Final Subsequent Program Environmental Impact Report  
Coachella Valley Water Management Plan Update

SCH No. 2007091099  
JANUARY 2012

# Section 12

## Additions and Corrections

Figure 8-2

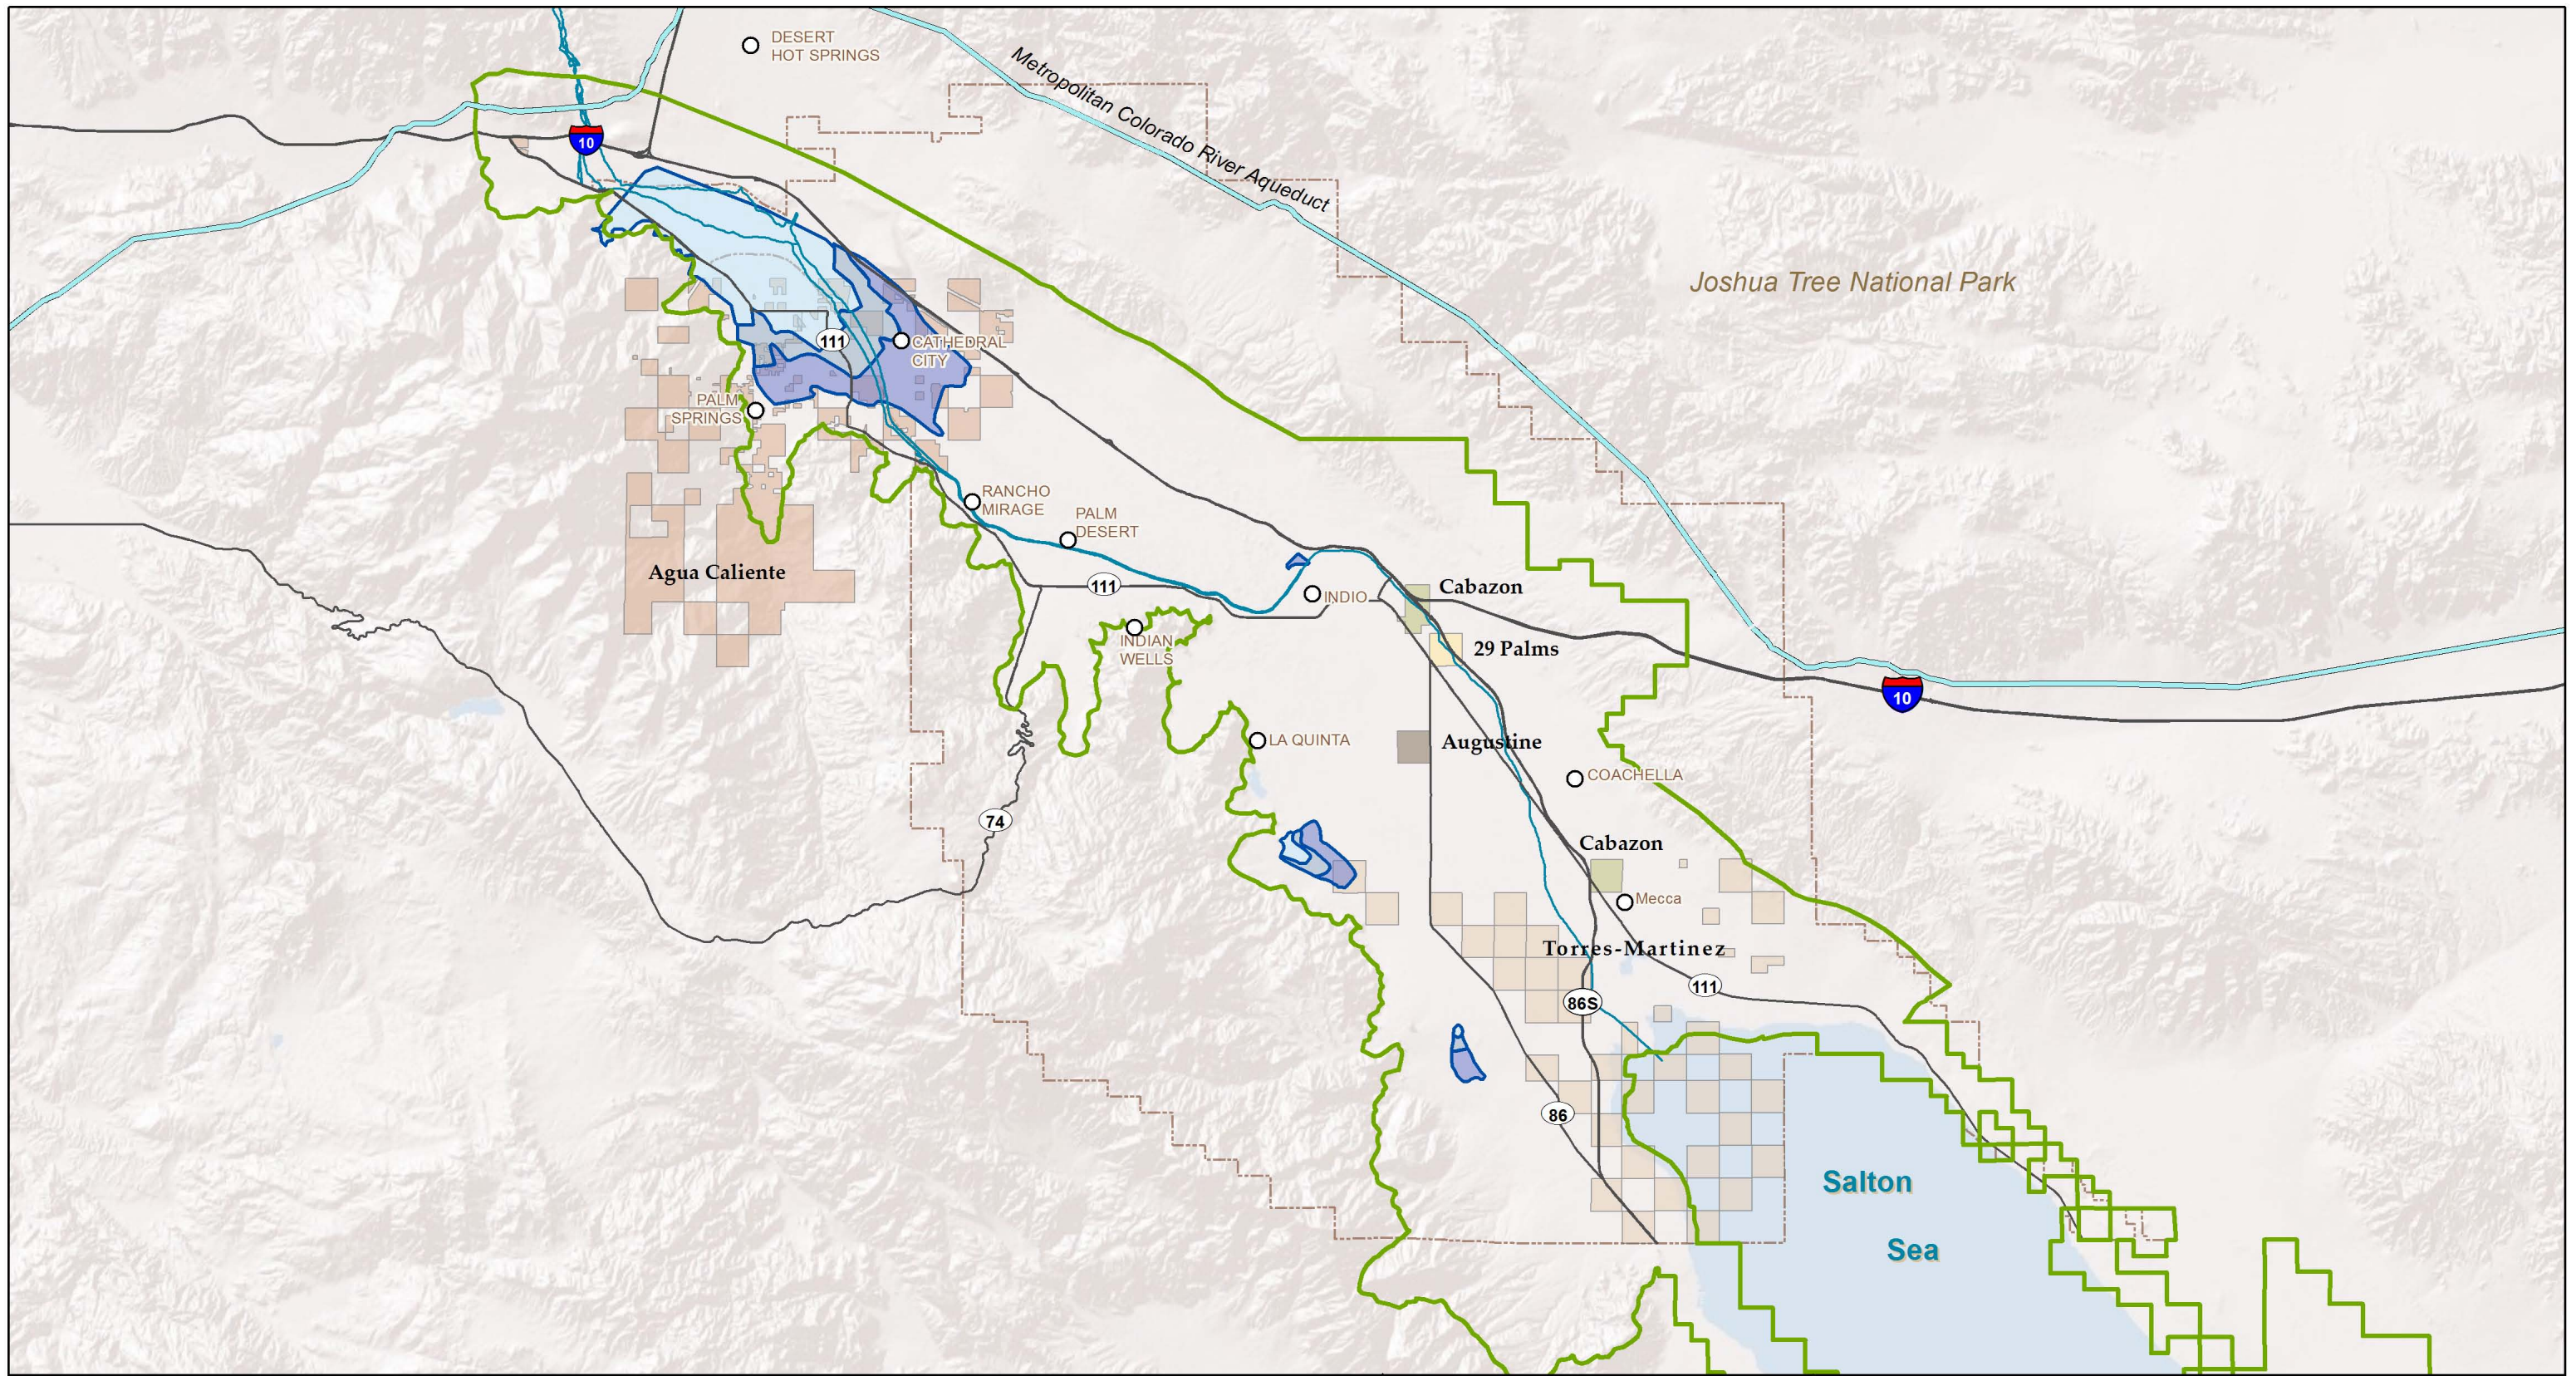
11. Labeling of tribal lands on SPEIR Figures 8-2 and 8-3, pages 8-65 and 8-67, respectively, is hereby modified (see revised figures on the following pages). The rectangular area of land immediately south of the word “Cabazon,” should be labeled “29 Palms,” and that designation should appear in the legend. The section shown immediately northwest of Mecca should be labeled “Cabazon.” These additions and corrections involve no new significant impacts or mitigation measures.
